Subject: ESTABLISHMENT OF IGNITION KEY KNOB BASE	Bulletin No: 09-019/12
	Last Issued: 05/09/2012

BULLETIN NOTE

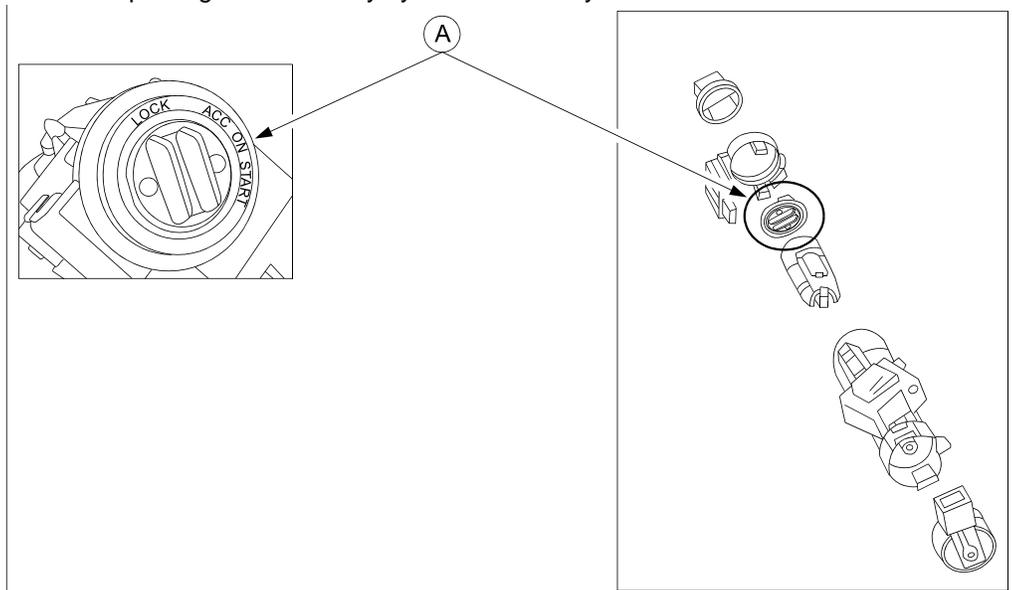
Some vehicles may experience the removeable ignition switch knob no longer snaps onto the ignition switch. If this is the case, be aware that the knob base (A) has been established as a new service part. Use the knob base part instead of replacing the entire key cylinder assembly.

Part Number	Part Name
D6Y1-76-142	Knob Base
